SERIAL EFFECTIVITY  KBU 722, S/N 1112 KBU 223, S/N 291	EQUIPMENT AFFECTED RC700 RC722/KBU 722/KBU 723 Keyboard
---	--

# FIELD CHANGE ORDER

NO. 19-012

Output Buffer

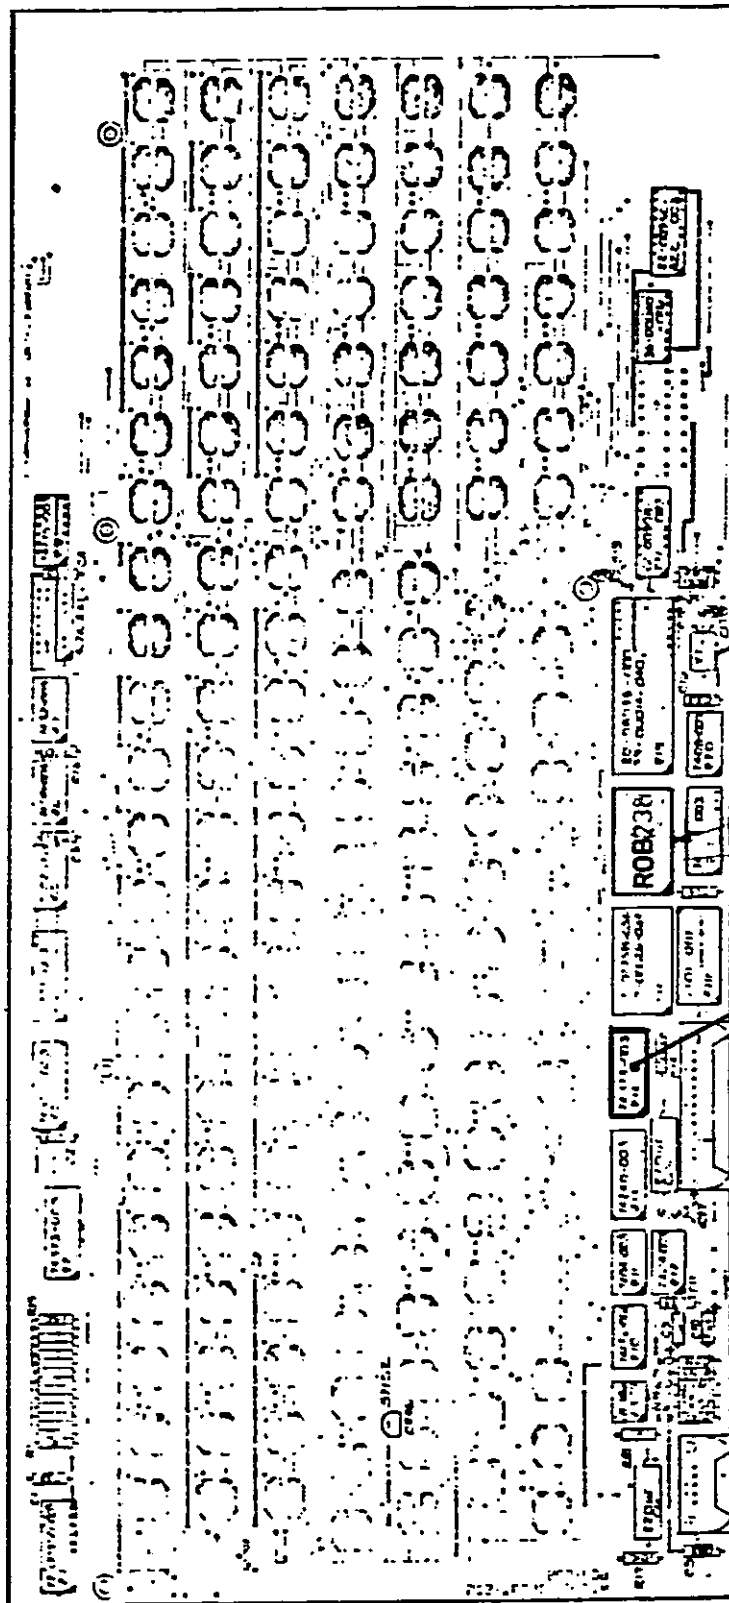
Signals coupled in the keyboard cable may change the output of bit 0 from a logical zero to a logical one. Pressing the keys "."0" (point, zero) may result in "."1" (point, one). The buffer is 'back set'.

1. Change the Output Buffer 74LS374 to a type not manufactured by National Semiconductor. See next page.
2. Code the FCO-label 19-012.
